UNITED STATES PATENT AND TRADEMARK OFFICE

APPLICATION NO.	FILING DATE	FIRST NAMED INVENTOR	ATTORNEY DOCKET NO.	CONFIRMATION NO.
09/633,573	08/04/2000	Wilson T. Asfora	00-0050	2575
40158	7590	11/17/2005	EXAMINER	
WOODS FULLER SHULTZ & SMITH P.C.			MAYNARD, JENNIFER J	
ATTN: JEFFREY A. PROEHL			ART UNIT	
P.O. BOX 5027			PAPER NUMBER	
SIOUX FALLS, SD 57117			3763

Office Action Summary

DETAILED ACTION

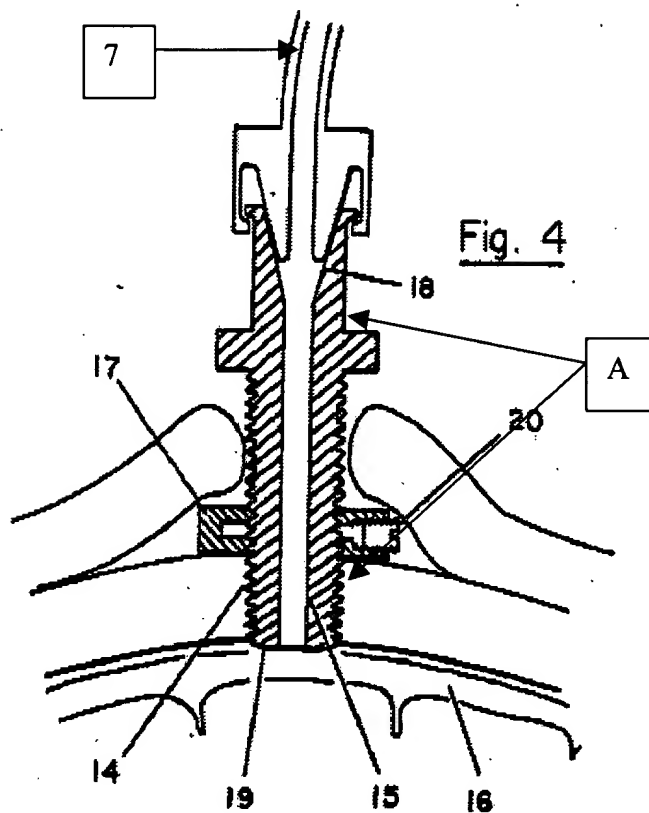
Swann et al. discloses an adjustable screw comprising a tubular portion (A, see labeled figure below) capable of being inserted into a an opening in a skull of a patient, the tubular portion having a proximal end (19) and a distal end (18) and a lumen (15) extending between the proximal and distal ends, the tubular portion having an exterior surface; a pair of wings (21) for facilitating finger rotation of the tubular portion, the wings extending outwardly from the tubular portion in substantially opposite directions from the tubular portion; self-tapping threads (14) formed on the proximal end of the tubular portion; a drill bit (32) for forming an opening in the skull of a patient; a stop collar (33) selectively lockable in a position on the drill bit for setting a maximum penetration of the drill bit into a surface; and a conduit (7).

Swann et al. fails to disclose a retaining means on the exterior surface of the tubular portion adjacent to the distal end for engaging an interior surface of a conduit with a flexible wall to releasably retain the conduit on the distal end of the tubular portion.

Huppee discloses a barbed tubing connector (10) comprising a tubular portion (12) including retaining means (18) on the exterior surface of the tubular portion adjacent to the distal end for engaging an interior surface of a conduit with a flexible wall to releasably retain the conduit on the distal end of the tubular portion.

It would have been obvious to one having ordinary skill in the art to have modified Swann et al. with a retaining means as taught by Huppee so as to enable higher operating

pressures while maintaining a leak free connection without the need for complex connection means on the cooperating end of the flexible conduit.

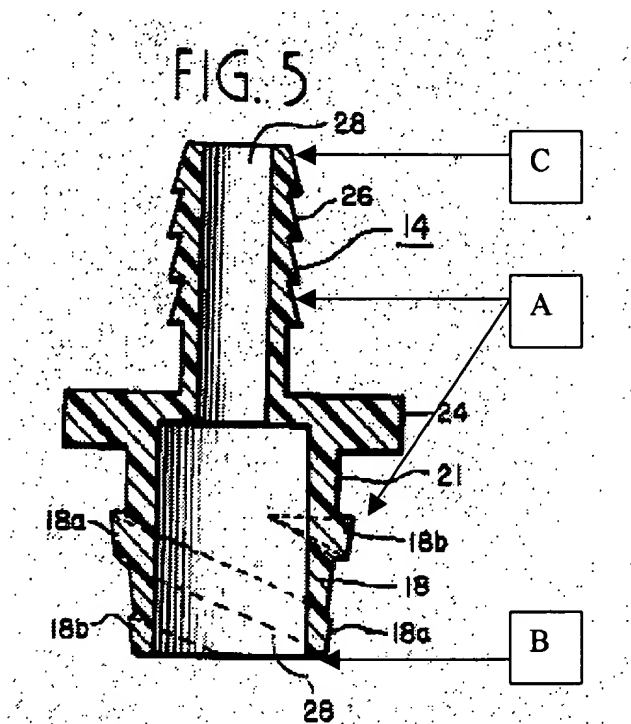
Akers discloses a connector (10) comprising a tubular portion (A, see labeled figure below) capable of being inserted into a an opening in a skull of a patient, the tubular portion having a proximal end (B, see labeled figure below) and a distal end (C, see labeled figure below) and a lumen (28) extending between the proximal and distal ends, the tubular portion having an exterior surface; retaining means (26) on the exterior surface of the tubular portion adjacent to the distal end for engaging an interior surface of a conduit with a flexible wall to releasably retain the conduit on the distal end of the tubular portion; and self-tapping threads (18a, 18b) formed on the proximal end of the tubular portion.

Akers failed to disclose a pair of wings for facilitating finger rotation of the tubular portion, the wings extending outwardly from the tubular portion in substantially opposite directions from the tubular portion.

Berg discloses a tap comprising a tubular portion (11) including a pair of wings (14, 14') for facilitating finger rotation of the tubular portion, the wings extending outwardly from the tubular portion in substantially opposite directions from the tubular portion.

It would have been obvious to one having ordinary skill in the art to have modified Akers connector with a pair of wings as taught by Berg to provide means for providing torque to the connector so as to aid in manually threading the connector into the opening.
